**COUNTY OF SAN MATEO
PLANNING AND BUILDING DEPARTMENT**

SUBJECT: Consideration of the approval of a Coastal Development Permit, pursuant to Section 6328.4 of the County Zoning Regulations, and Design Review Permit, pursuant to Section 6565.3 of the County Zoning Regulations, to allow the construction of a new, two-story, 3,201 sq. ft. single-family residence with an attached 502 sq. ft. garage on a previously developed, legal, 6,132 sq. ft., parcel located at 130 Sonora Avenue in the El Granada area of San Mateo County. The project involves only minor grading and no tree removal. The project is appealable to the California Coastal Commission. In conjunction with the requested permits, it is recommended that the Planning Commission determine that the project is categorically exempt from California Environmental Quality Act (CEQA) pursuant to CEQA Guidelines Section 15303.

County File Number: PLN 2022-00367 (Uccelli/Kellond)

Location: 130 Sonora Avenue, El Granada

1 FRONT ELEVATION (SOUTHWEST) 3/16"=1'-0"
 0 3 6 12

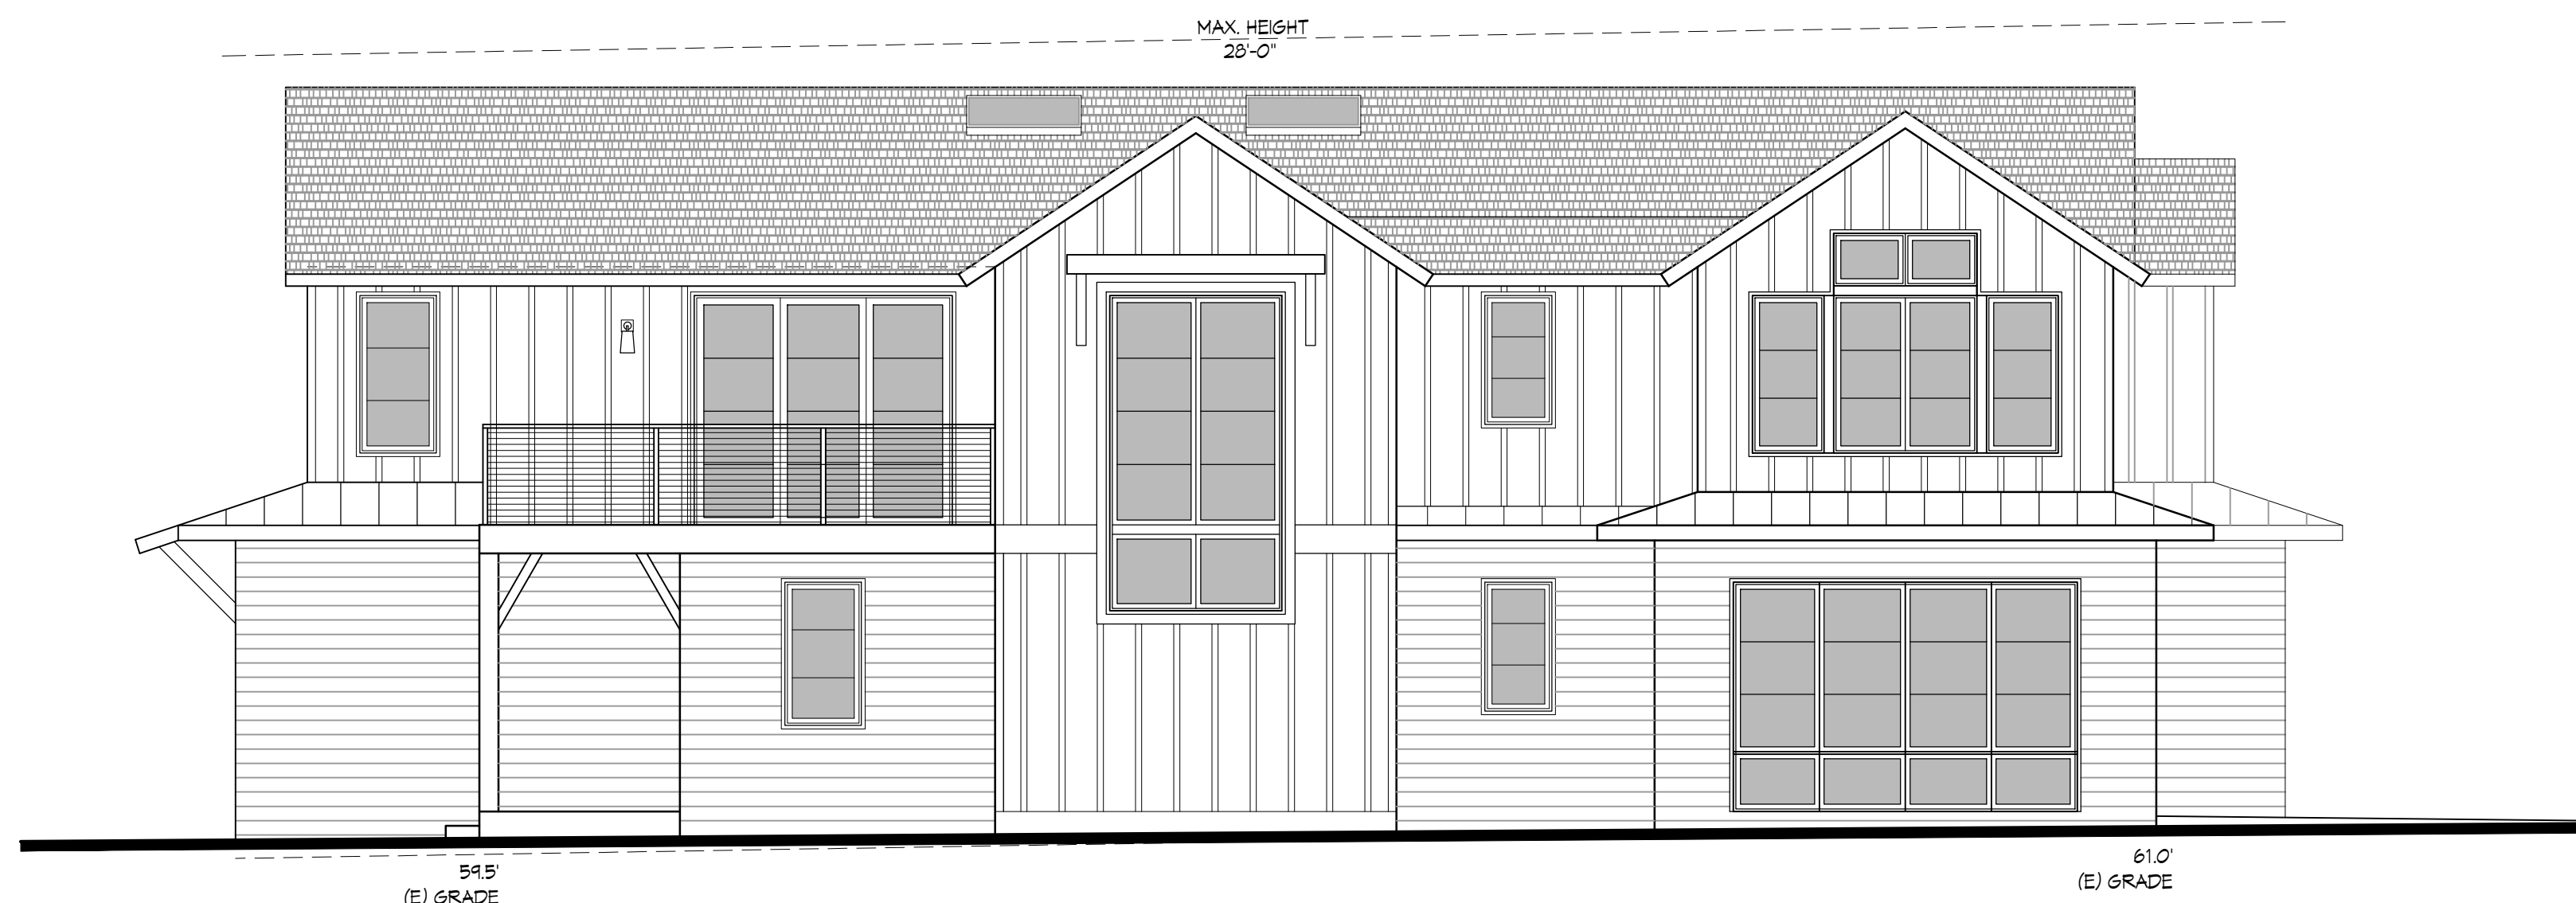
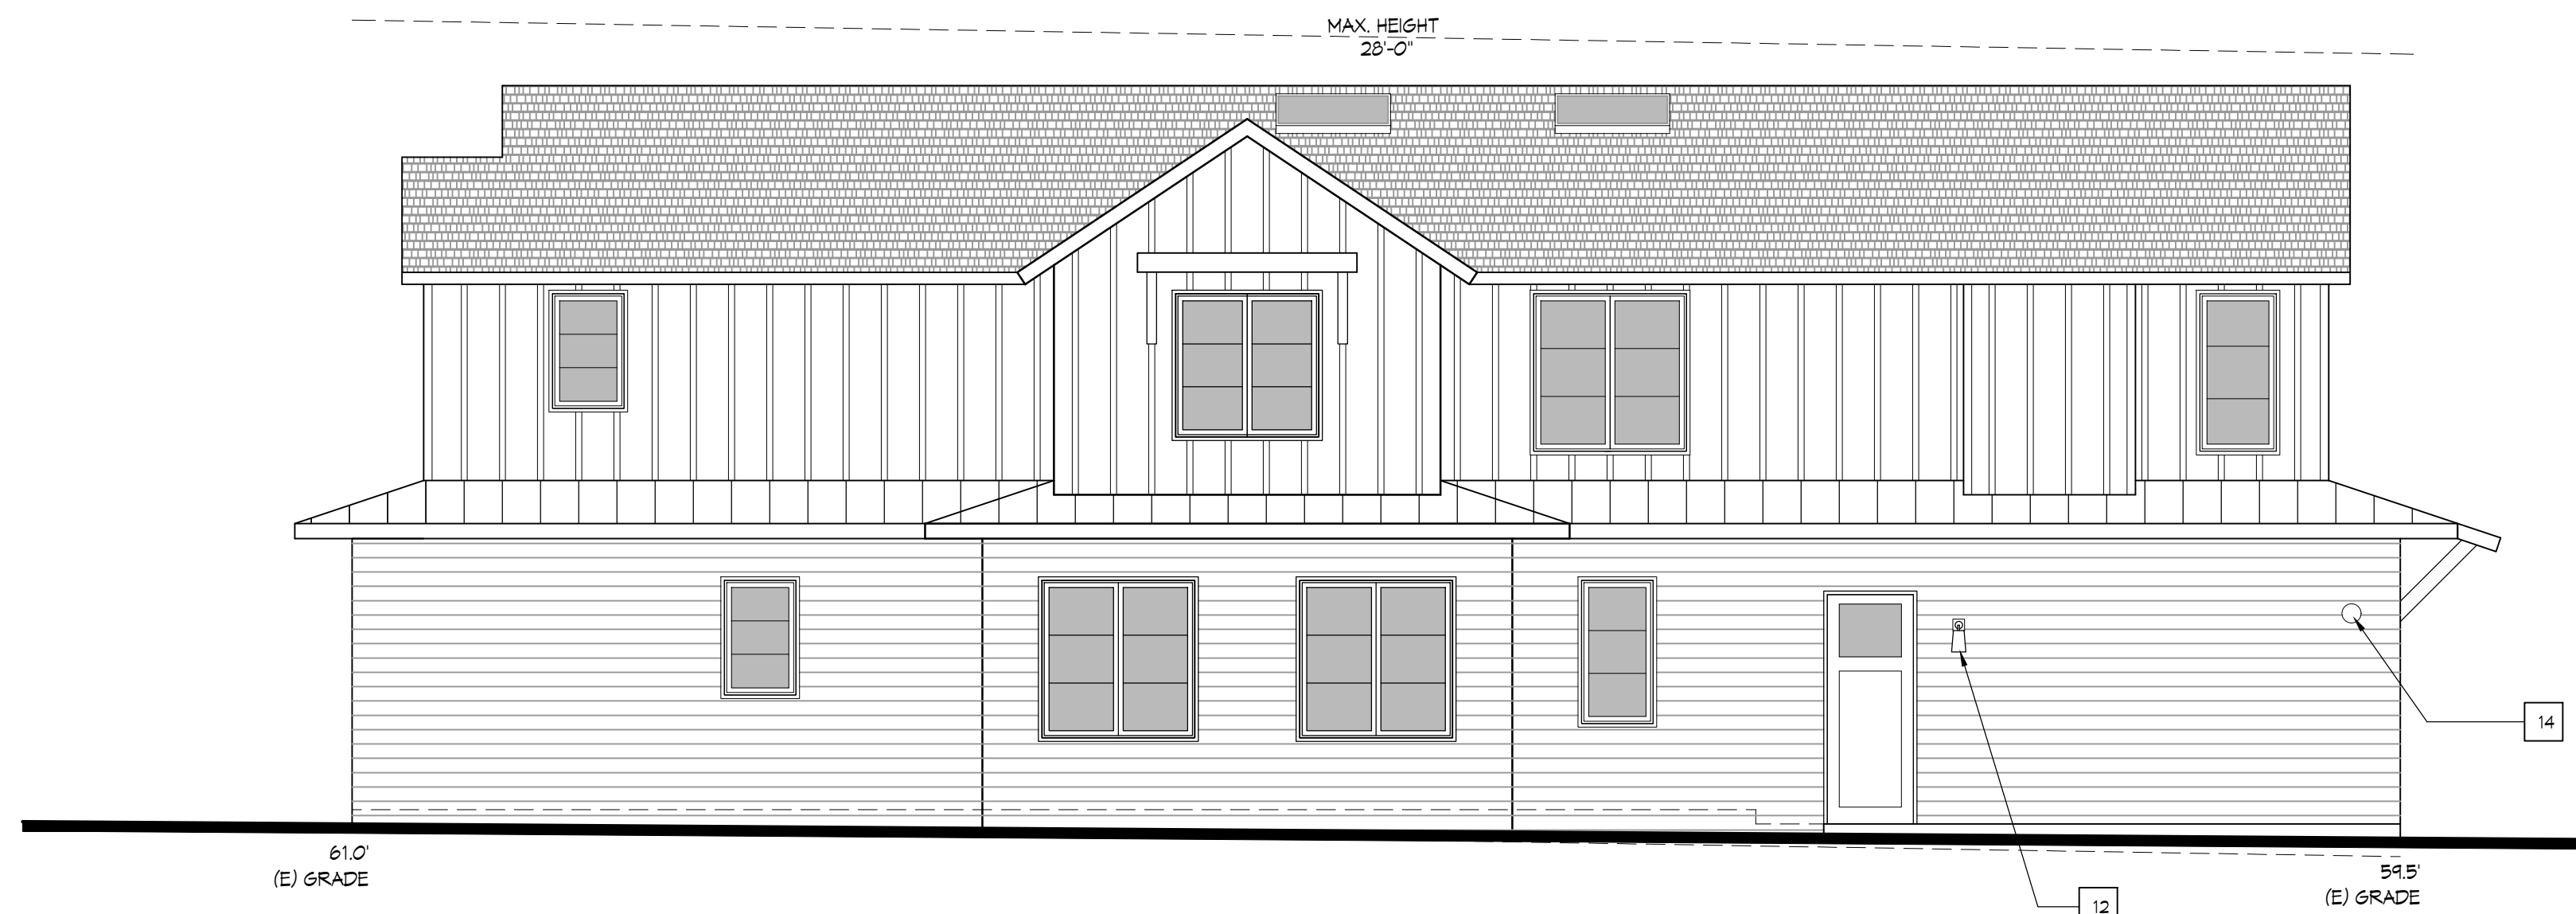
4. The applicant shall indicate the following on plans submitted for a building permit, as stipulated by the Coastside Design Review Committee:
 - a. Section 6565.20(D) ELEMENTS OF DESIGN; 4. Exterior Materials and Colors; Standards a. (3): Change the Level 2 roof color of composition shingle from black to brown to reduce the stark contrast between the roof color and the Level 2 exterior wall color.
